FCC ID: NP4MCUB5Q

FCC Correspondence Reference Number: 19852

Form 731 Confirmation Number: EA101316

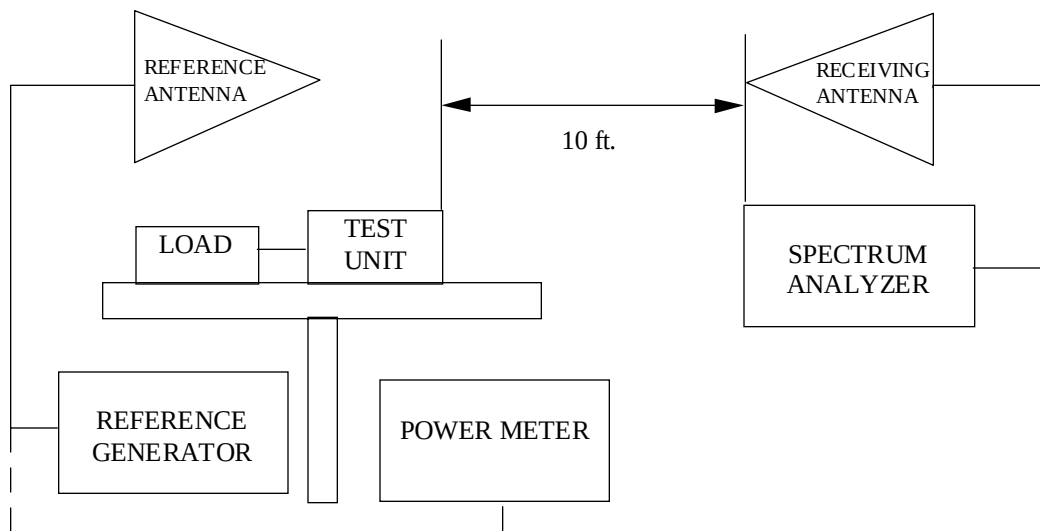
QUESTION 2) The attenuation requirement under Section 90.210(e)(3) is $55 + 10\log(P)$ which equates to 62 dB for this device at high power (5 W) and 55 dB at low power (1 W). Your test data results for radiated spurious emissions show non-compliance with these limits. Please resolve this issue.

The test data in the original report was incorrectly measured to the wrong specification limits. Modification was made to the unit to improve shielding of a connector that was causing non-compliance with the correct specification. The radiated spurious data was re-measured and the unit now meets the FCC requirement. The recorded data is included at the end of this response.

TEST RESULTS: Meets minimum standard (see data on the following page)
